RCWD BOARD OF MANAGERS REGULAR MEETING AGENDA

Wednesday, October 9, 2024, 9:00 a.m.

WORKING DOCUMENT: This Engineer's report is a draft or working document of RCWD staff and does not necessarily reflect action by the RCWD Board of Managers.

Figure 3 - Proposed Plan and Wetland Impact

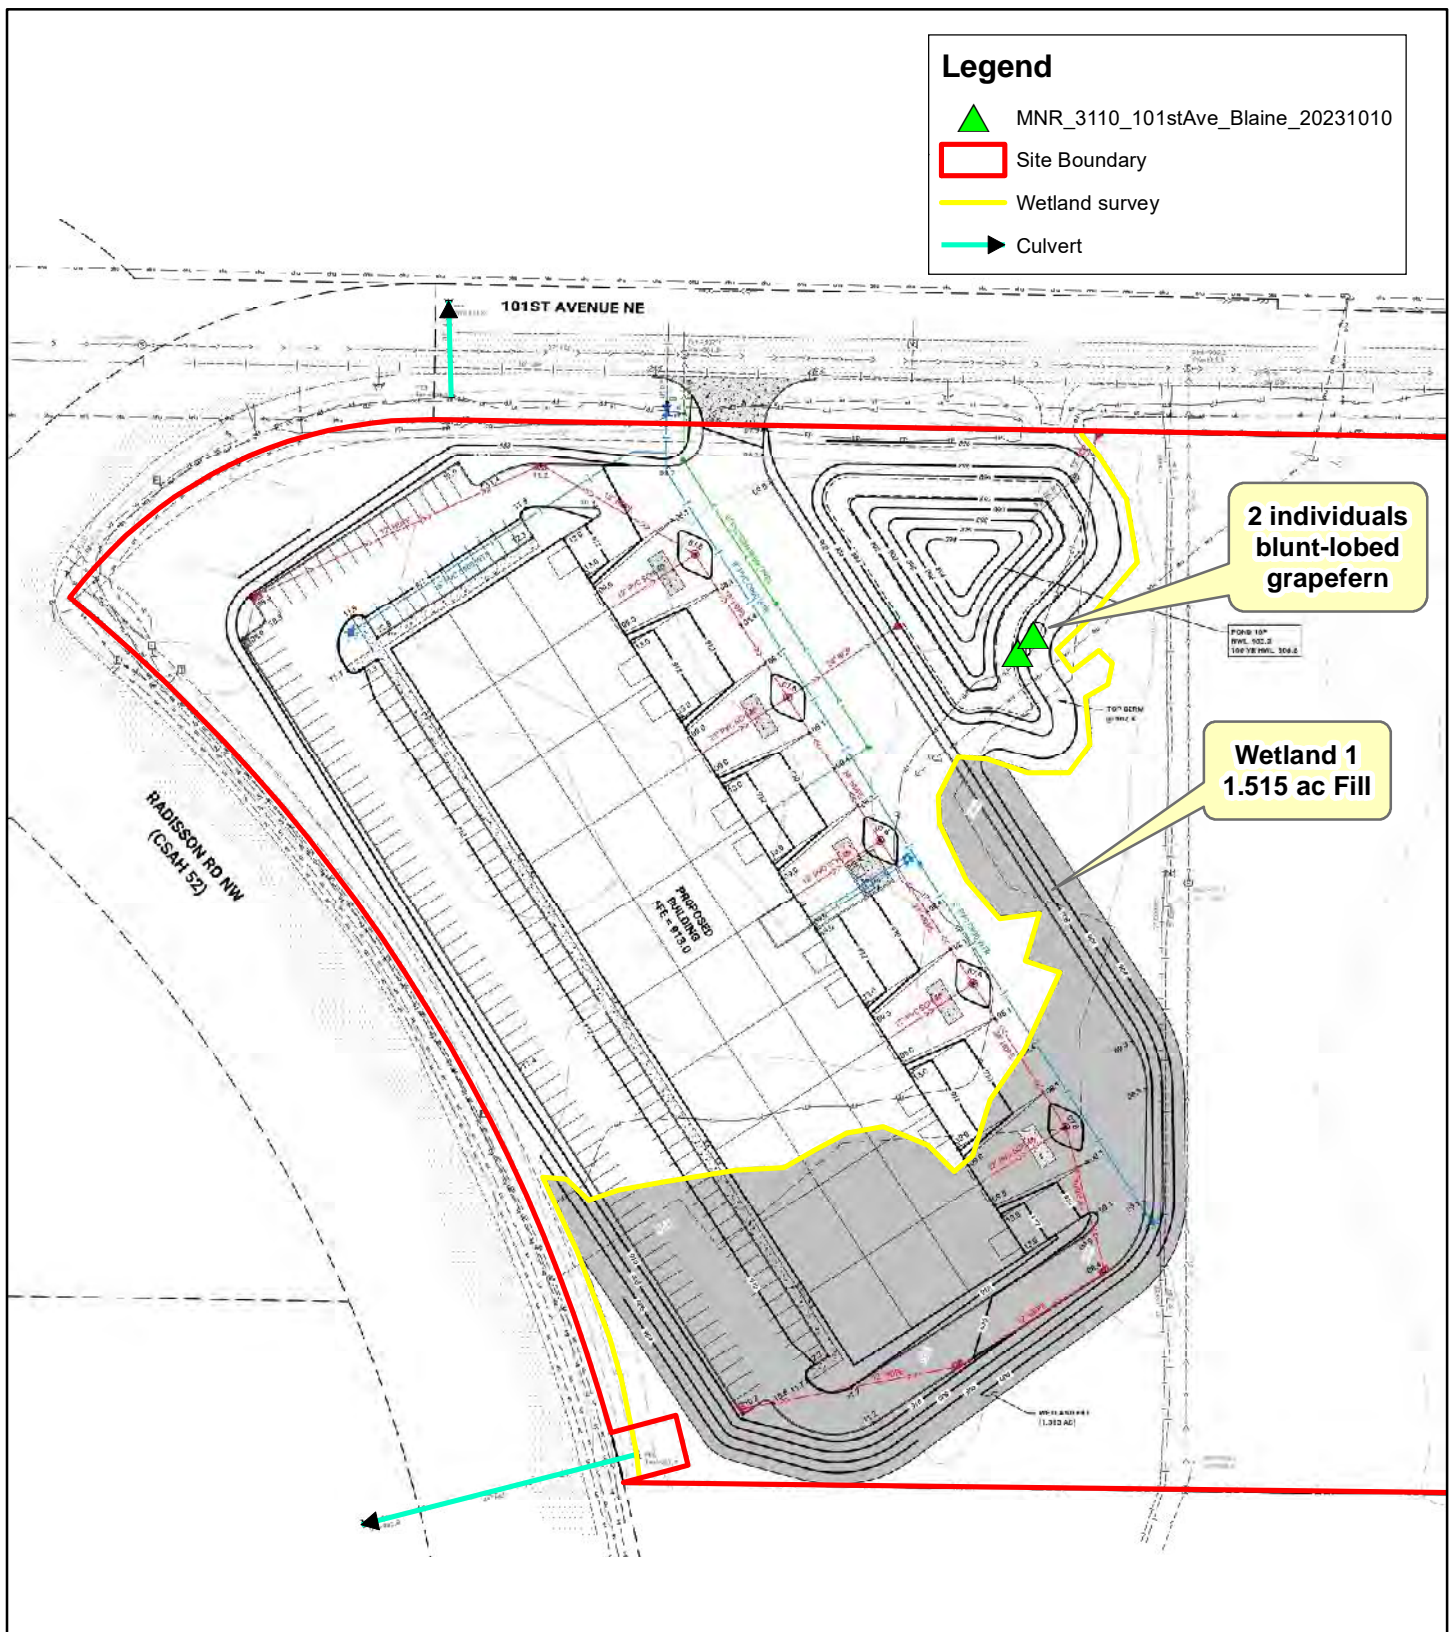
The proposed plan showing wetland impacts for the Radisson Business Center project is provided in Appendix C. A general overview of impact area is shown on Figure 3. The proposed design considers site constraints and meets all of the project requirements as described previously.

The identified rare plants are proposed for impact for construction of a stormwater pond (Figure 3). A take permit application will be submitted to MN DNR for proposed impacts to protected species.
